June 19, 2026

Sarah Kliegman
Co-Executive Director
Okanogan Highlands Alliance
Tel: 509-560-4429
E-mail: sarah@okanoganhighlands.org

**Comments on the Draft Supplemental Environmental Impact Statement (DSEIS) for the
Key Mill Tailings Storage Facility - Filtered Tailings Stack Height Raise**

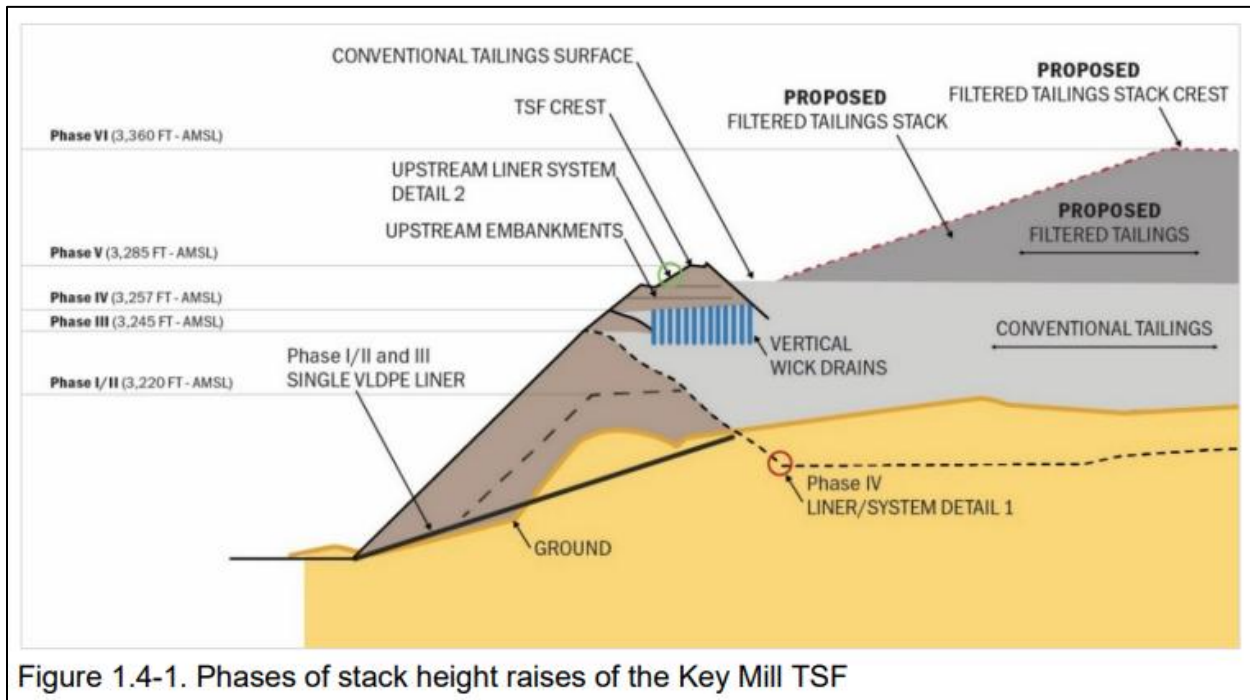
The filtered tailings storage facility would be constructed on top of an existing tailings storage facility that was constructed using the upstream method (see Figs. 1a-b, 2) with the excessively steep slope of 1V:2H (1 meter vertical for two meters horizontal) (see Fig. 3). The upstream construction method was known to be unsafe even three decades prior to the use of the method at the Key Mill Tailings Storage Facility. The construction of outer embankments with such excessively steep slopes was known to be unsafe at the time of construction of these embankments at the Key Mill Tailings Storage Facility.

Although the existing tailings storage facility was constructed using unsafe methods, the central assumption of the DSEIS is that the construction of a filtered tailings storage facility on top of the existing facility will improve the stability of the existing facility. The assumption is that weight of the additional tailings would compact the underlying tailings, thus forcing out water that would drain downward through the vertical wick drains that would be constructed (see Fig. 2).

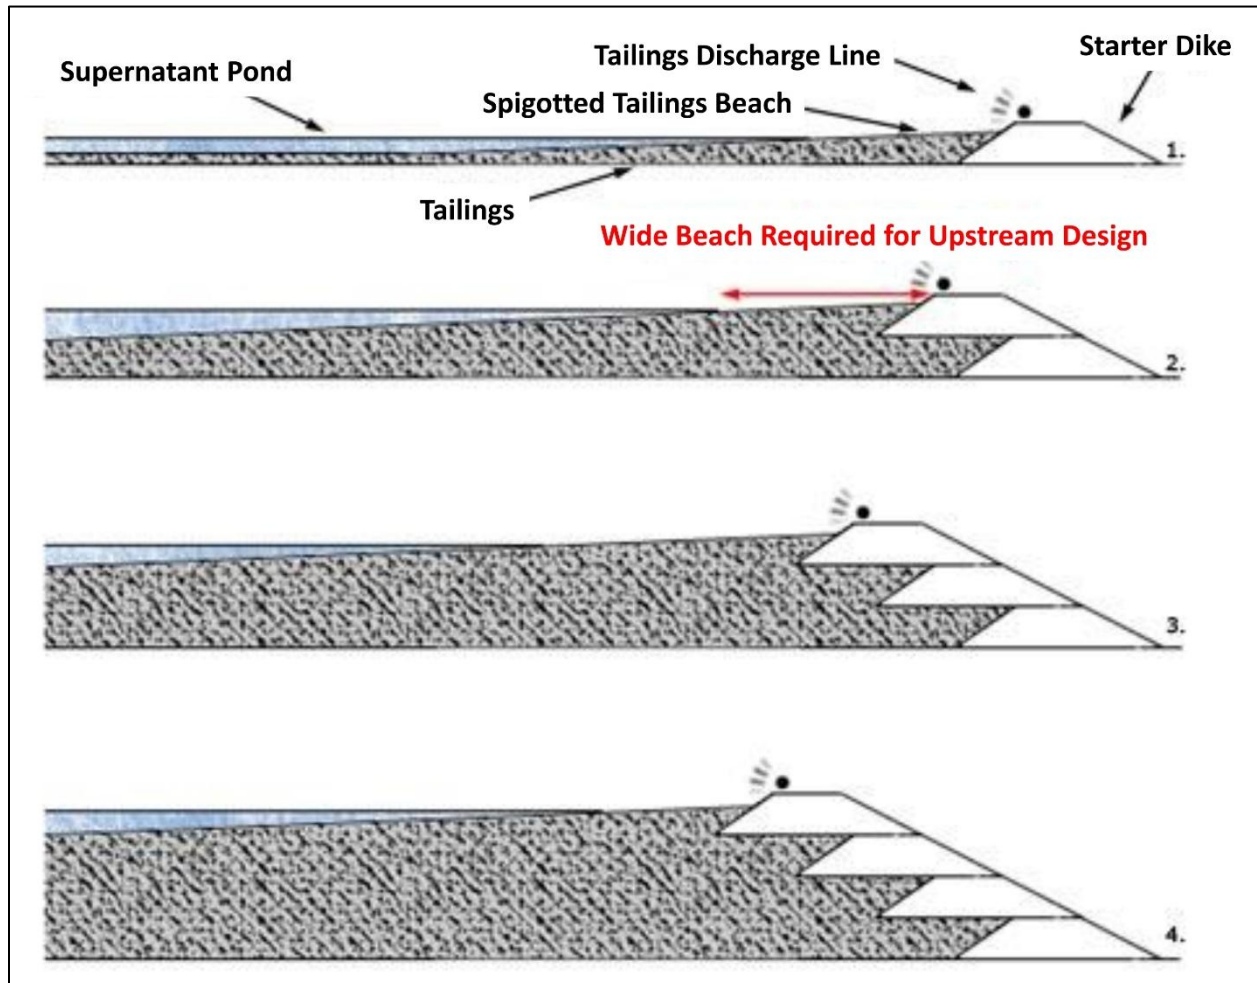
From another perspective, an upstream dam is constructed on top of an unknown foundation (see Fig. 4a; Fuller, 2019). An accurate knowledge of the foundation is an essential feature of dam safety since both tailings dams and water-retention dams have failed due to yielding or settling of the foundation. The geotechnical properties of the tailings underlying the dikes can be predicted, but they are not actually known until they can be measured after dikes have been constructed on top of them. In the same way, the future evolution of the tailings (for example, due to compaction by the overlying dikes or drying of the tailings) can be predicted, but is not actually known until the future has occurred. This feature of upstream dams sets them apart from any other type of dam in which the geotechnical properties of the foundation can and should be a known quantity before the dam is constructed.
